# Durham Bicycle & Pedestrian Advisory Commission

SUBJECT: Case Z1400027 – Guglhupf Parking Expansion

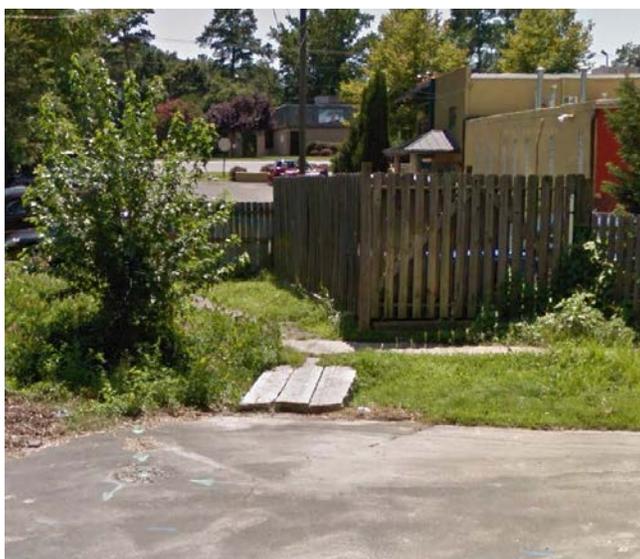
Below is a photo of the existing pedestrian connection between Francis Street and the Guglhupf site. This primitive connection is not accessible to those with disabilities and also does not work well with strollers or bicycles.

1. Add text commitment on the development plan to provide an accessible pedestrian connection between Francis Street and the existing or proposed parking lot for Guglhupf, subject to approval by the City of Durham, to be addressed during the site plan approval process.
2. Add text commitment on the development plan to provide bicycle parking on the existing Guglhupf site that meets Durham Unified Development Ordinance standards, to be addressed during the site plan approval process.
